RED SKY APARTMENTS
10140 S CENTENNIAL PKWY
SANDY, UTAH 84094

SITE PLAN REVIEW UPDATE

PROJECT: RED SKY APARTMENTS

Application No. SPR12062022-006452

L111
LANDSCAPE

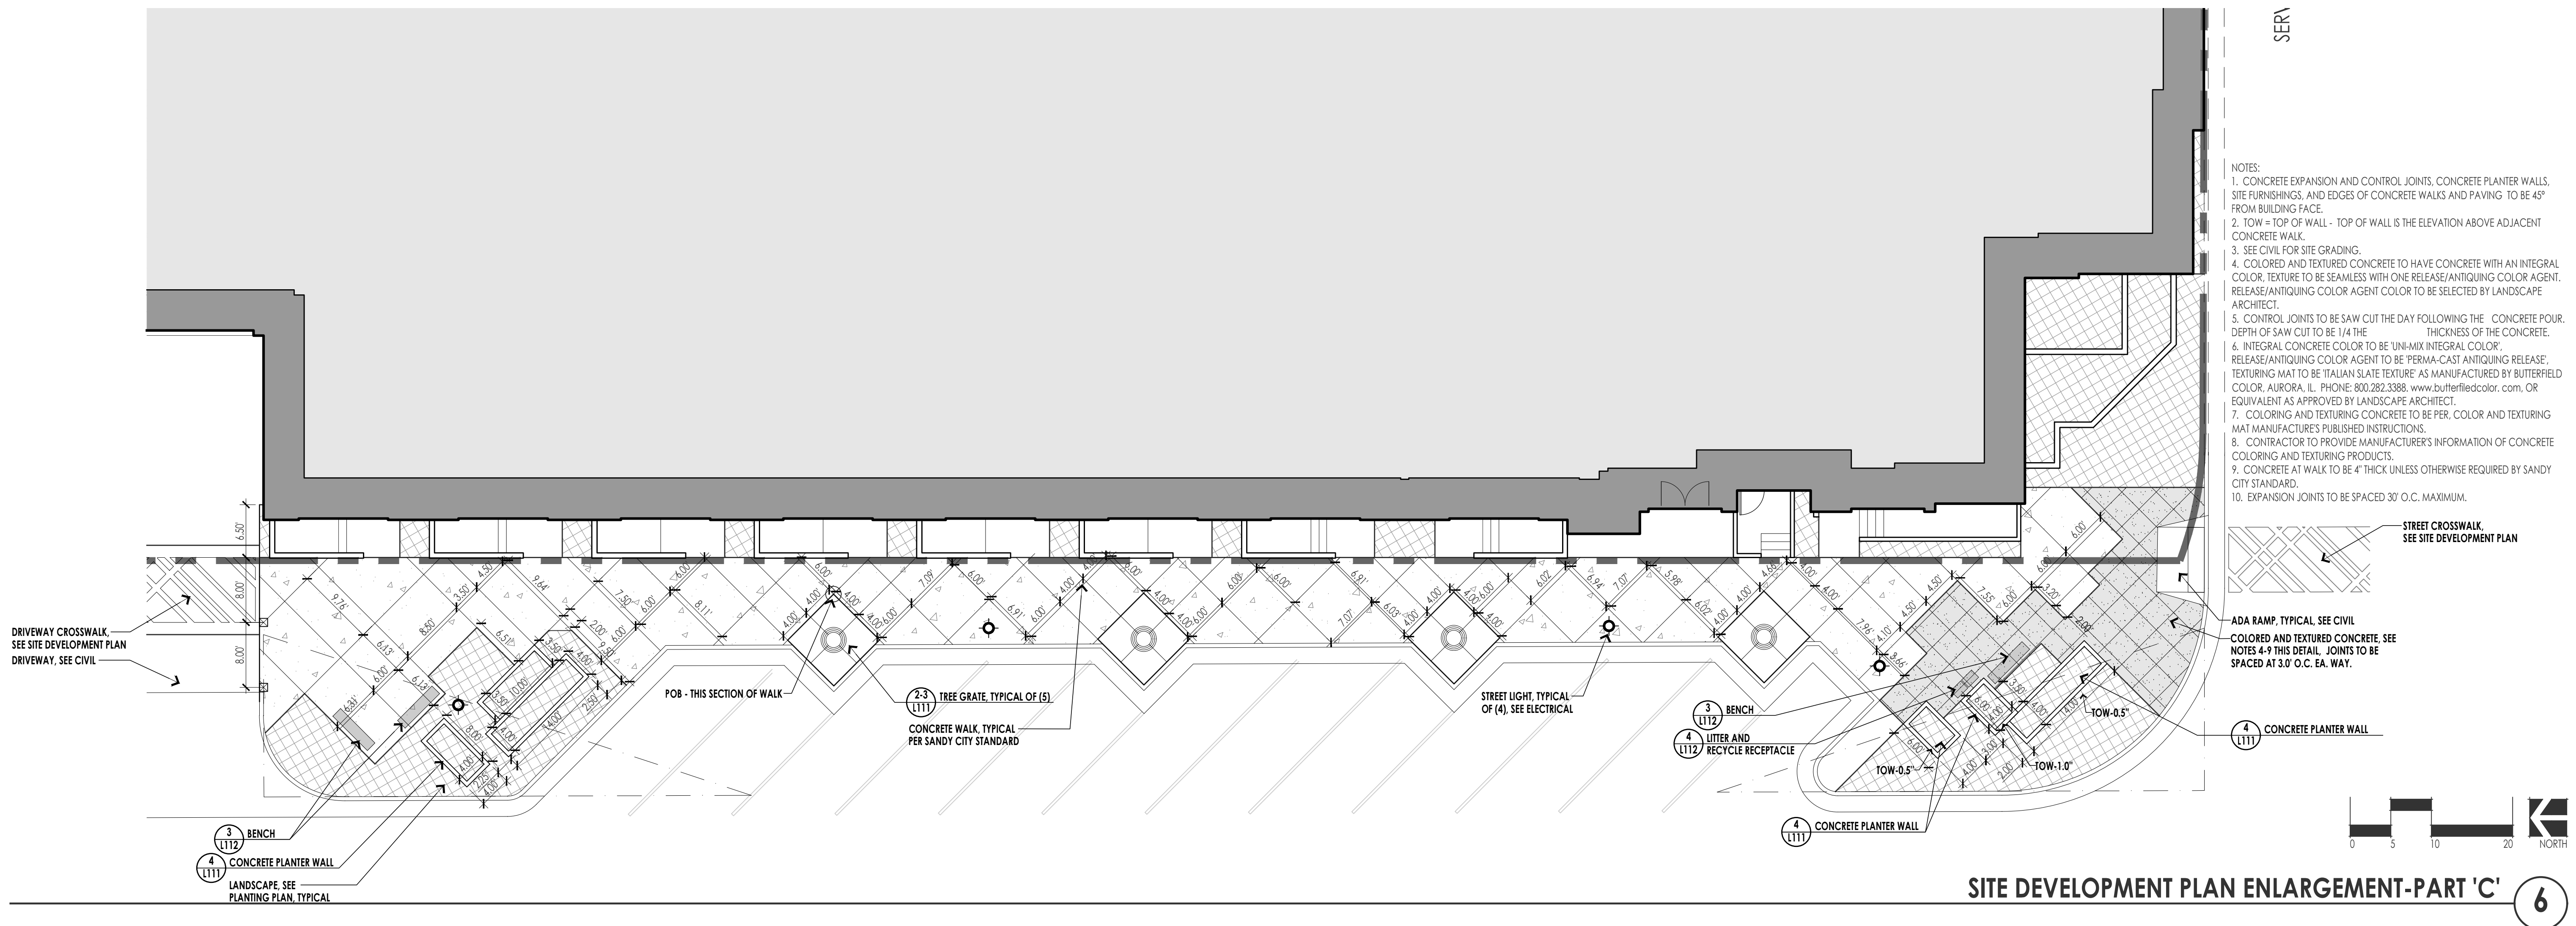
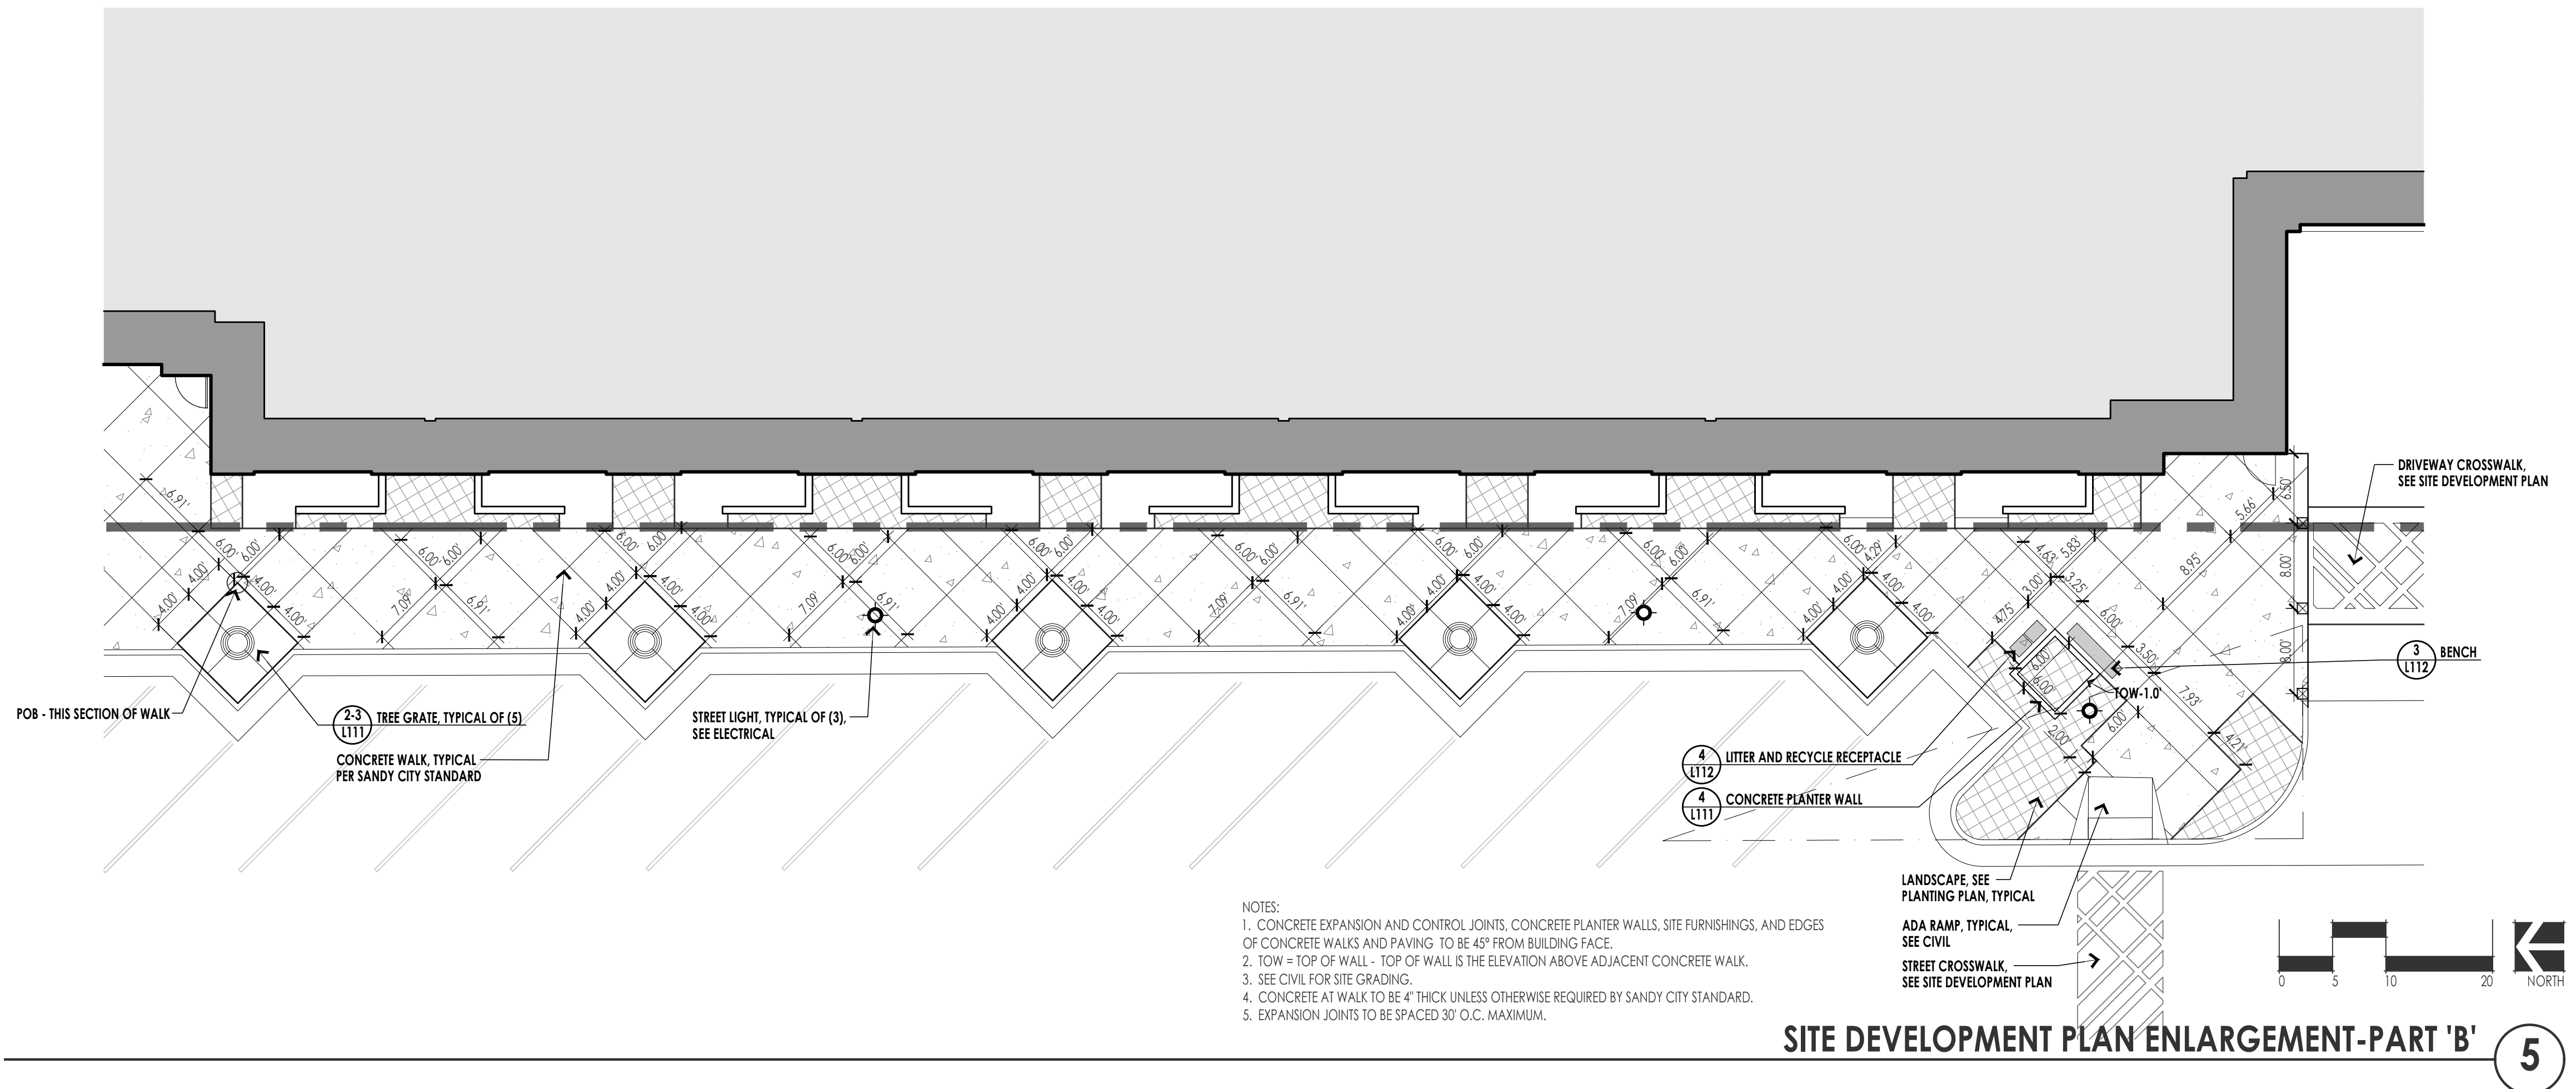
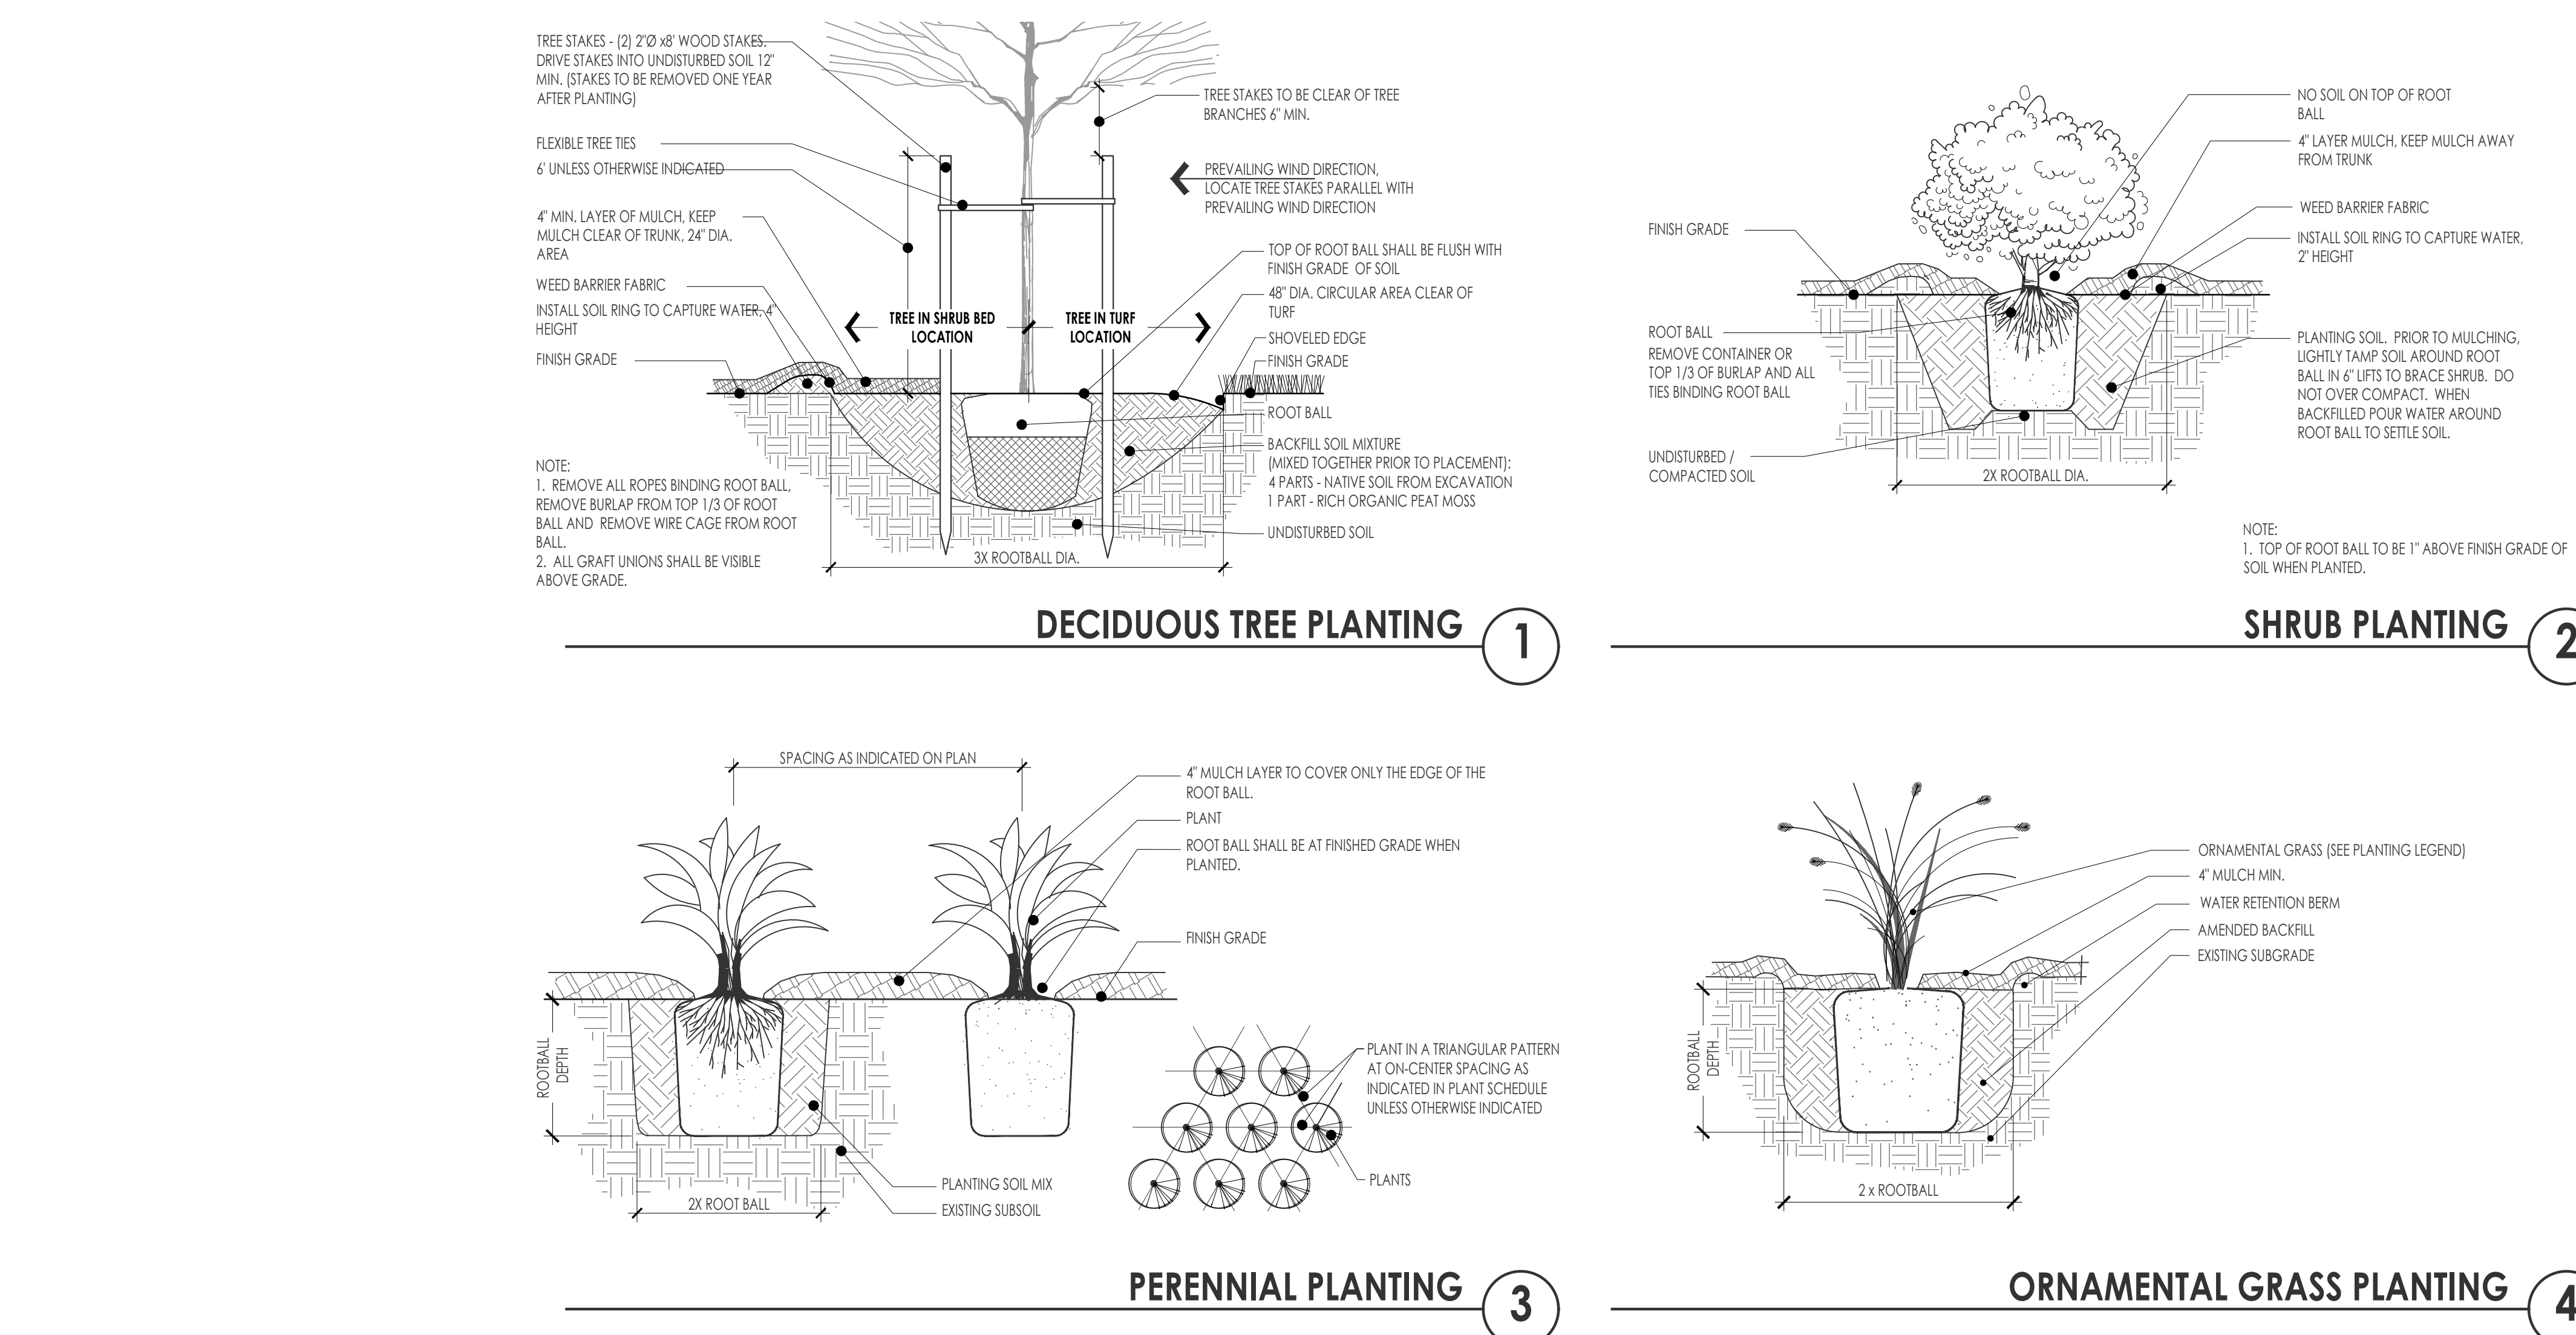
Design Standard	Response
7.1 Furnishings	
<u>Tree grates, manhole covers, and sidewalk medallions</u>	<i>City Comment: Place within building space</i> Response: '2.1.3 Pedestrian Realm' does not specify location of tree grates, manhole covers and sidewalk medallions in any of the three spaces. The proposed design offers above and at grade planter boxes in the Landscape Space. See Landscape Plans
Manhole covers shall be Cairns branded and have an additional identifying marker indicating storm water, water, etc.	<i>City Comment: You should have some new ones and replace the existing ones within the scope of the development.</i> Response: noted on Civil drawings
Tree grates shall provide at least 16 square feet of permeable surface.	Proposed design complies. See L111
Tree grates, manhole covers, and sidewalk medallions shall be crafted using high-quality materials or come	<i>City Comment: Provide detail and call-out locations.</i> Response: Added to civil drawings. See L111

from the pre-approved list in Appendix B of this document	
<u>Trash Receptacles</u>	
Privately maintained trash receptacles should be placed in the building zone every 100 to 200 feet	<p><i>City Comment: Add one additional set (see redlines)</i></p> <p>Response: Street frontage has been redesigned. Trash receptacles have been added near every entrance, less than 200' from each other.</p> <p>See L111</p>
Recycling receptacles should be paired with at least 1/2 of all trash receptacles (also to be placed in the building zone and privately maintained)	Proposed design complies. See A001 & L111
Trash receptacles shall be crafted using high-quality materials or come from the pre-approved list in Appendix B of this document	Proposed design complies. See L111
<u>Bike Racks</u>	
Each project shall have one bike rack that can accommodate a minimum of 4 bicycles	<p><i>City Comment: Not shown on plan. Add by commercial areas and lobbies.</i></p> <p>Response: Bike rack included on north end of site, near commercial.</p> <p>Proposed design complies. See A001 & L111</p>
